ROAD SAFETY AUDIT REPORT

OREGON DEPARTMENT
OF TRANSPORTATION
OR 8: SW 17th Avenue
to S 26th Avenue

ROAD SAFETY AUDIT (RSA) REPORT

OR 8: SW 17th Avenue to S 26th Avenue Washington County, Oregon

Exhibit 30: Illustration of Roundabout Option

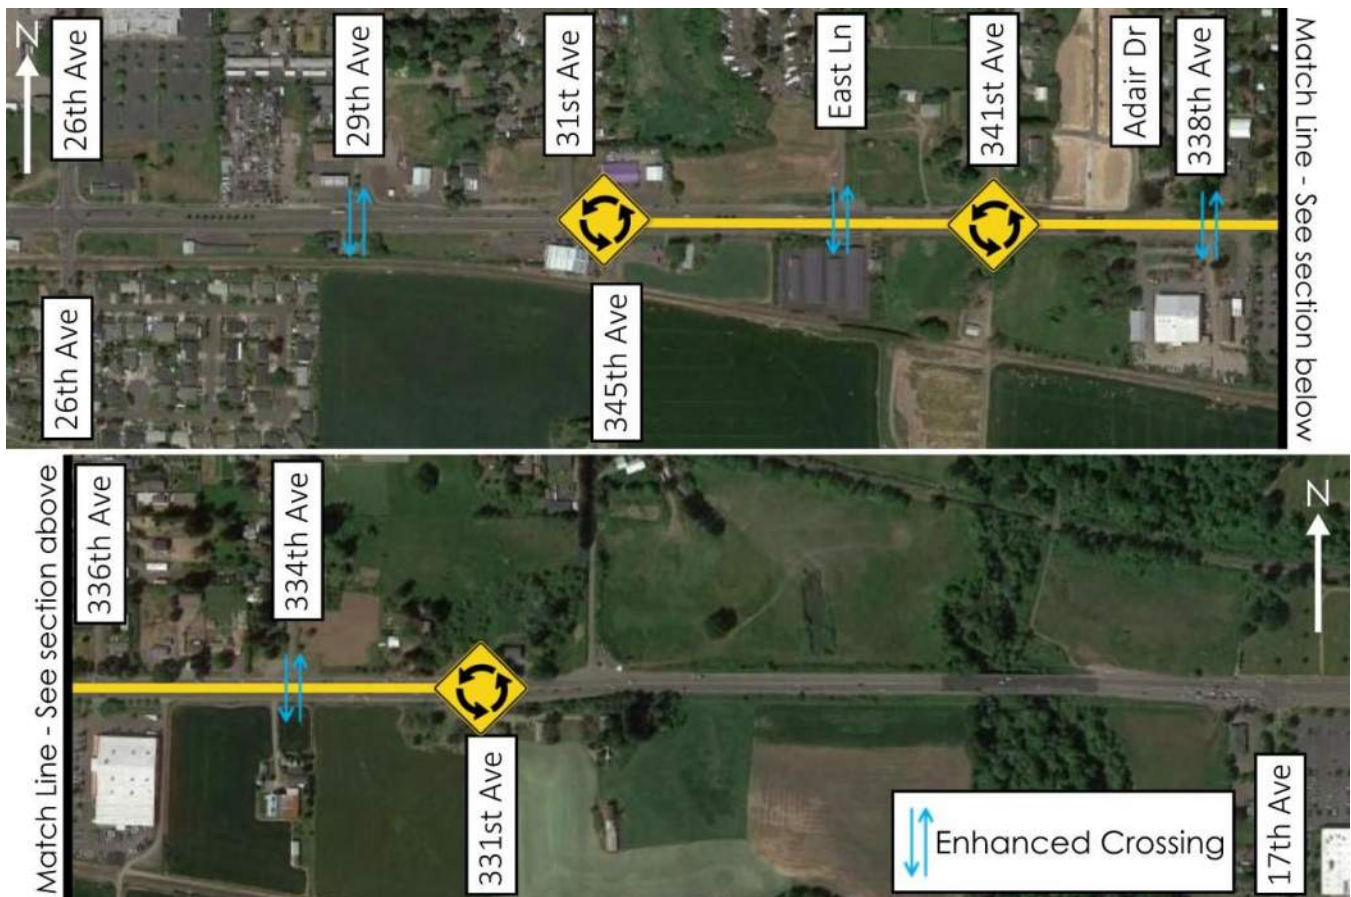
This option would involve installing roundabouts at key locations to provide access and facilitate U-turns, as shown in Exhibit 30. Unlike the signalized intersection option, frontage roads would not be needed because roundabouts accommodate U-turn movements. However, the roundabouts may require additional right-of-way at the locations where they are constructed. Similar to the signalized option, a raised median would be constructed along OR 8 to limit access points to right-in, right-out only. Roundabouts provide an additional speed management benefit to all users requiring all vehicles to slow when approaching and navigating the roundabout. A series of multiple roundabouts on the study corridor would encourage slower speeds along OR 8 rather than simply in one location.

- 345th Avenue (including realignment of 31st Avenue as the north leg of the intersection)
- 341st Avenue
- 331st Avenue

Install Roundabout from Minor Road Stop Control
CRF: 82% reduction in all injury crashes
ODOT Countermeasure Number: H16
